**UNITED STATES
NUCLEAR REGULATORY COMMISSION
ADVISORY COMMITTEE ON REACTOR SAFEGUARDS
WASHINGTON, DC 20555 - 0001**

SUBJECT: CERTIFIED MINUTES OF THE MEETING OF THE FUKUSHIMA
SUBCOMMITTEE ON OCTOBER 19, 2016

ADVISORY COMMITTEE ON REACTOR SAFEGUARDS
MINUTES OF THE ACRS FUKUSHIMA SUBCOMMITTEE MEETING
ON OCTOBER 19, 2016

The purpose of the meeting was to discuss draft Regulatory Guides 1.226, 1.227 and 1.228 in support of the mitigation of beyond design basis events rulemaking. The meeting focused primarily on Regulatory Guide 1.226 and Revision 3 to NEI 12-06. Revision 3 includes guidance for mitigation strategy assessments for the new seismic hazard information that applies to all plants where the ground motion response spectrum is greater than twice the safe shutdown earthquake within 1 to 10 hertz frequency range. Recent changes to Regulatory Guides 1.227 and 1.228 were also discussed. The meeting transcripts are attached and contain an accurate description of the matters discussed during the meeting. The presentation slides and handouts used during the meeting are attached to these transcripts.

Interaction of Mitigating Strategies Order, Rule and Reevaluated Hazards

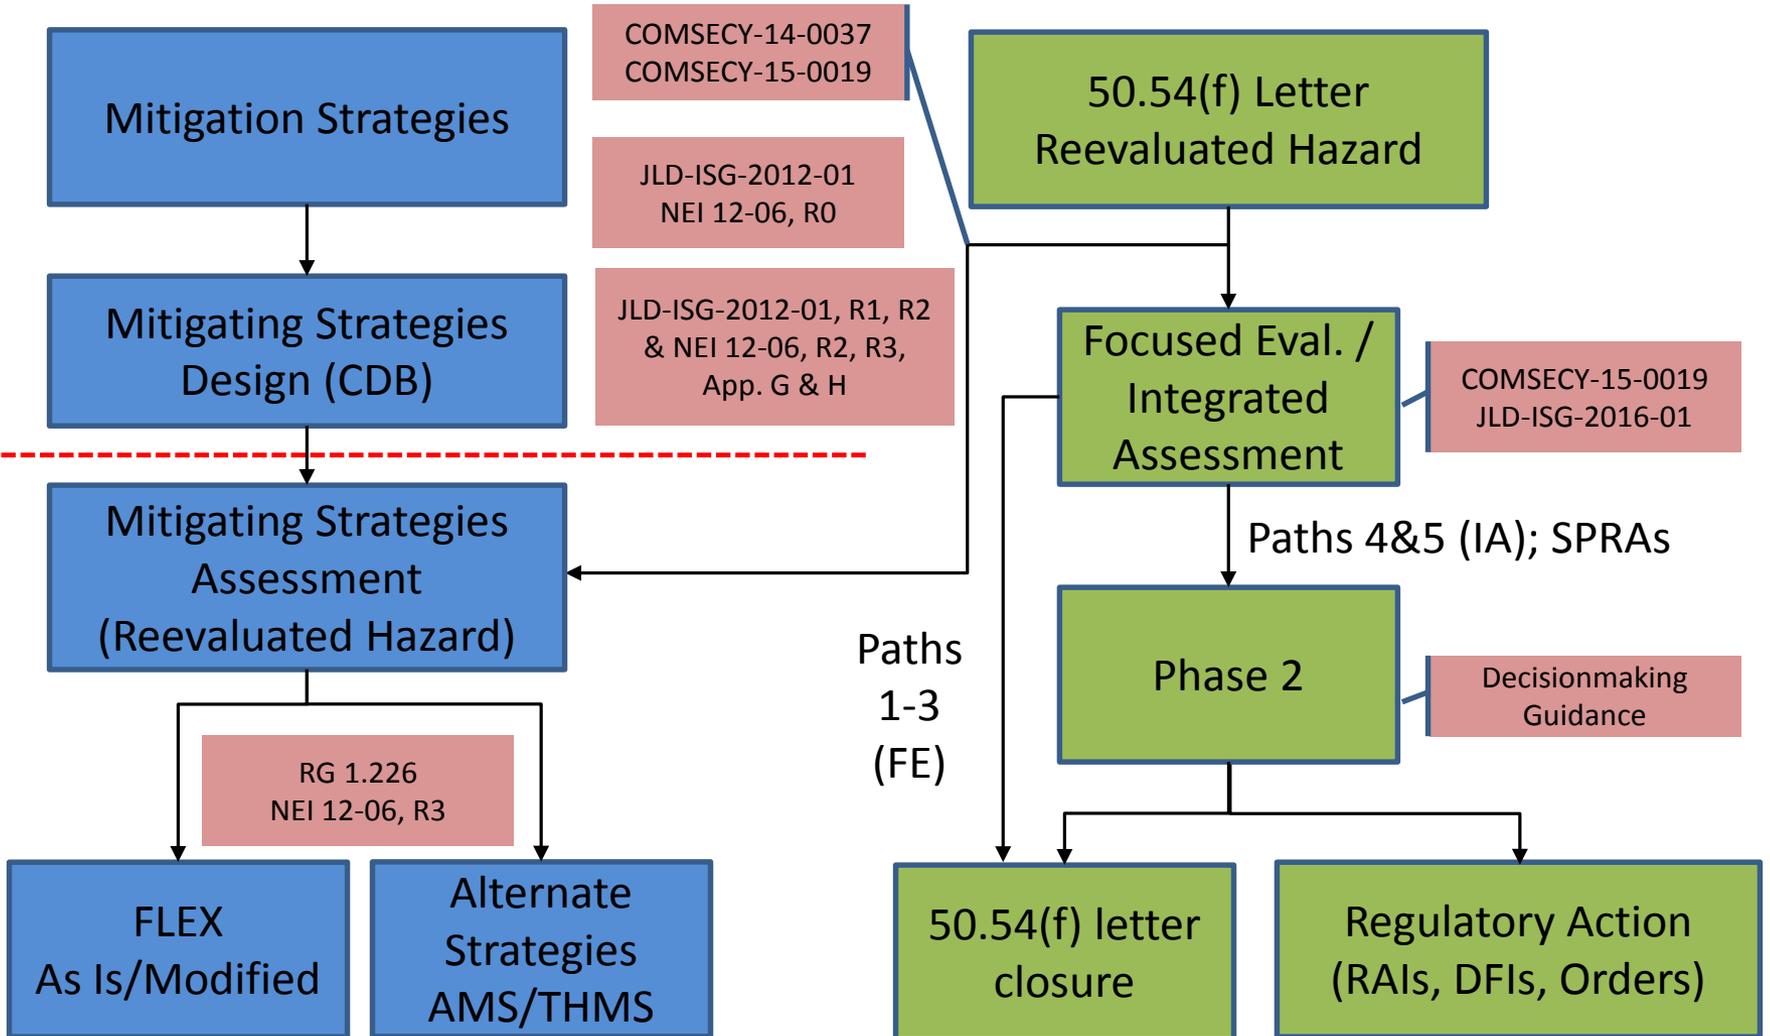
21. S. Schultz commented that the flow chart could be improved by including arrows to show the integration of the blue and green paths as described in COMSECY-15-0019.	138
